Land at Rectory Farm (North), Yatton

Appeal Ref: APP/D0121/W/24/3343144

Response to Create Consulting Engineers Ltd
Note, Point 1

Figure 1 – Hazard Mapping from Hydrock FRA (CDA11) for 200yr plus climate change event, undefended with ground levels at 8.44m AOD.

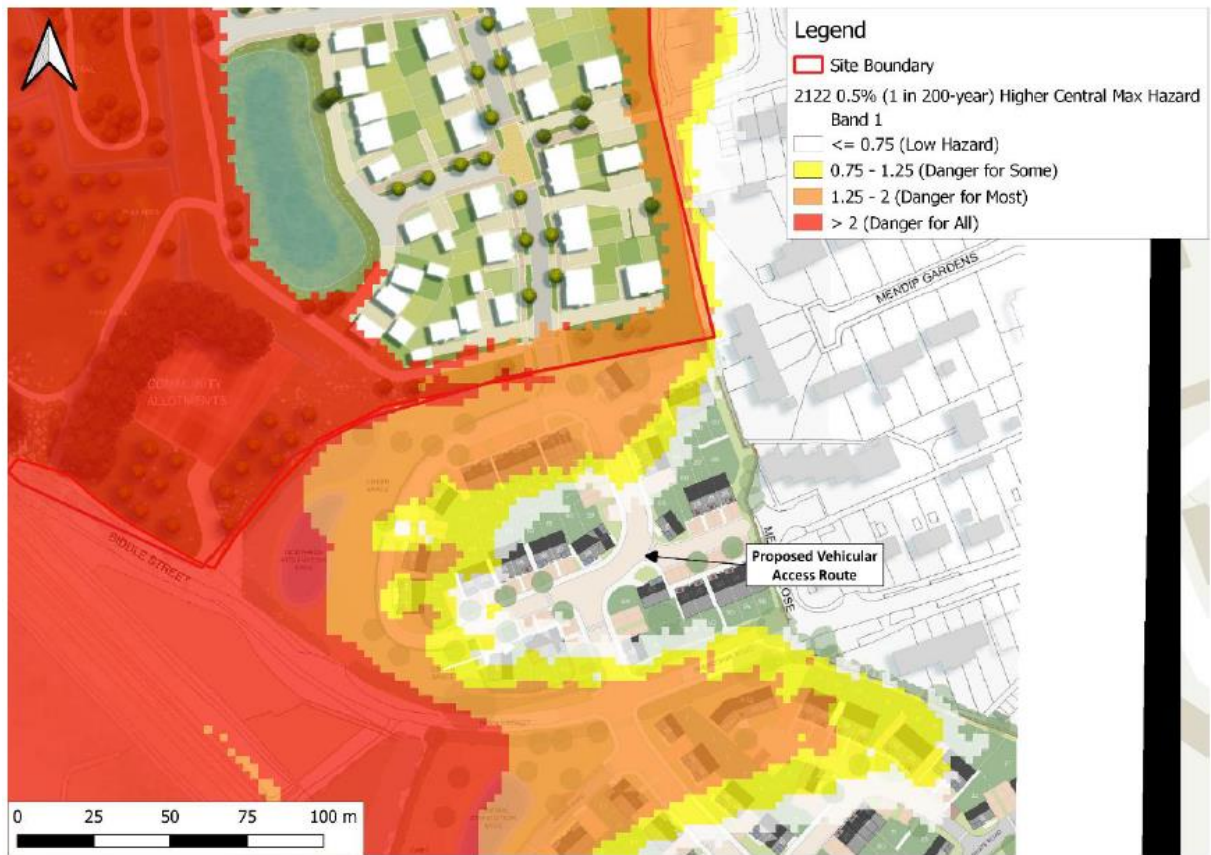
Figures 4.6 and 4.7 of the FRA show Hazard Mapping which has been based on the original Land Raising of 8.44m as outlined in the Hydrock FRA CDA11. If the ground level was dropped to 6.88m AOD then this would have a significant impact on the speed of inundation to the site, as the site would be lower as well as the overall depth of flooding that would be experienced across the site. These hazard maps are therefore wrong and do not show accurately the impact of the site both for the defended and undefended scenarios.

- 2.3 On review of the Hydrock document, and its supporting modelling, the below figure (Figure 22 from the Hydrock Report) has, as outlined in the Create note, been prepared using the 1 in 200 year plus higher central flood event for an undefended scenario for the development design life. The below figure has also included proposed ground levels being set at the first proposals at 8.44m AOD.

- 2.4 The above plan (and model outputs) has shown that both proposed access routes to the development (image taken from Hydrock report and Shiners Elms not shown, modelling outputs unavailable) would be within areas of increased hazard. However, interpretation of these extracts must be set against the inundation timings – and these being worst case. As shown, this flooding occurs during the 3rd tidal cycle and affects the site between 14 and 15 hours from the first overtopping of the defences in this 3rd tidal cycle with flows travelling from the defences before overtopping the railway line to the north and then initially flowing south into the site. Flows then latterly meet and then overtop the Strawberry Line to the west before reaching the site and then the access through to the St Modwen site.

Figure 2 – Hazard Mapping from Brookbanks (ID28) for 200yr plus climate change event, undefended with ground levels at 6.68m AOD.

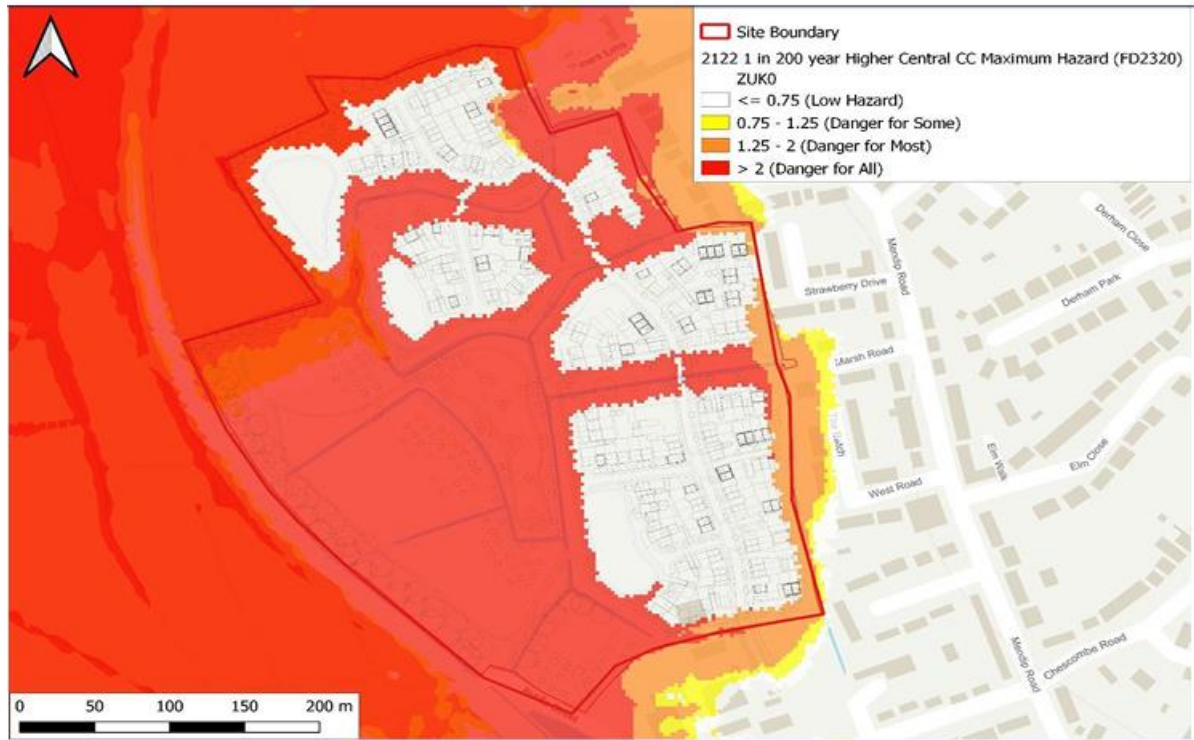
- 2.5 Mr Cage, in his note, refers to the outlined areas illustrating modelled hazards within the Brookbanks FRA (ID28): these areas being the same as those within the Hydrock report (CDA11) . Mr Cage queried these and how it would be expected for the outputs to look ‘significantly different’ in terms of extents and depths; owing to the much reduced ground level (6.68m AOD (a level which was subsequently agreed with the EA)) as opposed to 8.44m AOD as part of the evolving process and ongoing discussion with the EA at the time of the Brookbanks FRA (ID28) being prepared. To address this point, the modelling files have been sought from Brookbanks and reviewed. This process has confirmed that the ground level (in the Brookbanks model) was modelled as being at 6.68m AOD and therefore were different to those in the Hydrock modelling and outputs. However, the outputs shown on Brookbanks report figure 4.7 (and shown below) was based on the undefended scenario and not the now agreed defended design scenario (and so including the existing coastal defences).

- 2.6 As such, and as would be expected, the hazard ratings and outputs from the option with ground levels at 6.68m AOD are very similar to those within the Hydrock report (CDA11), as the movement, timing and depths were much increased compared to the now agreed defended scenario.

- 2.7 To address the comments raised by Mr Cage in relation to the timing of flooding reaching the site/access points being different in the various options considered throughout the evolution of the mitigation, and given the above figure is taken from an undefended scenario (i.e. as with the Hydrock Flood Hazard Mapping outputs) this therefore has no impact on the inundation times and explains the similarities.

- 2.8 It should again be noted that the Brookbanks report was never submitted, there is no reliance placed on the outputs from this. The position of the appellant is that both the Hydrock and Brookbanks reports (ID28 & CDA 11) have been superseded by the proposal to set ground levels to a revised, lower height of 6.43m AOD and therefore the subsequent modelling that was undertaken for this event in the defended scenario (following a meeting with the EA on 14th September 2023) is the assessment/outputs that should be used against the reasons for refusal stated within the Statement of Case.

Figure 3 – Hazard Mapping for 200yr plus climate change event, defended with ground levels at 6.43m AOD.

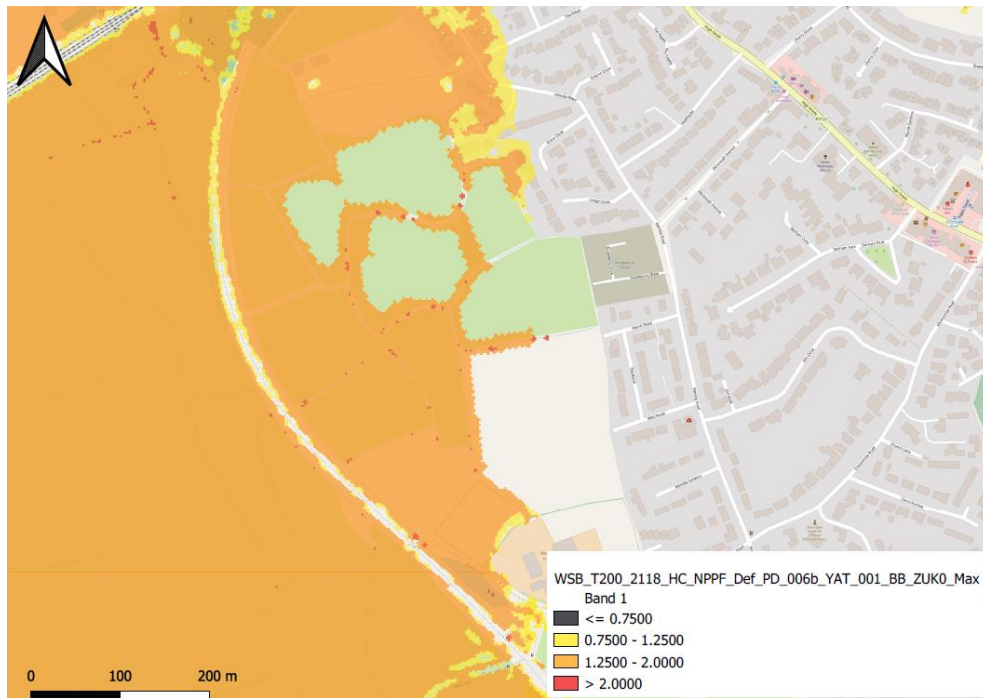
- 2.11 As part of this review, the inundation times have been compared between the undefended and defended events to address the comments provided. Whilst an academic exercise owing to a safe access route being available with the proposed ground raising with the agreed design event/scenario, this has shown that it remains as being the 3rd tidal cycle that leads to the first flooding reaching the site and, as before, this event first impacts the site between 14 and 15 hours from the first overtopping of the defences from the critical tidal cycle. The critical mechanism is the 3rd cycle of the tidal curve but also the height of key topographical features such as the railways embankments – which contains water until such point as over topping occurs.

- 2.9 The modelling that assesses the defended scenario for the 1 in 200 year plus higher central climate change event with finished floor levels set at 6.43m AOD does provided markedly different flood extents and hazard ratings when compared to those at Figures 1 and 2 of this Note, as would be expected owing to the inclusion of the existing defences and the protection these provided when compared to all defences having been ‘removed’. Figure 3 below shows the hazard ratings from the most recent, and current proposals, for site levels with the EA agreed design event.

- 2.10 Whilst the outputs shown in Figure 3 above are significantly different from those within both the Hydrock and Brookbanks FRA documents and pose a lesser risk/hazard to the site and surrounding area, Shiners Elms remains as being categorised as being at Danger for Some/ Danger for Most at the peak of the event. However, the proposed southern access through the St Modwen land to the south, and as identified within Mr Bunn’s Proof, is shown as being within Flood Zone 1 and ‘Low Hazard’ and therefore providing suitable safe access and egress from the development.
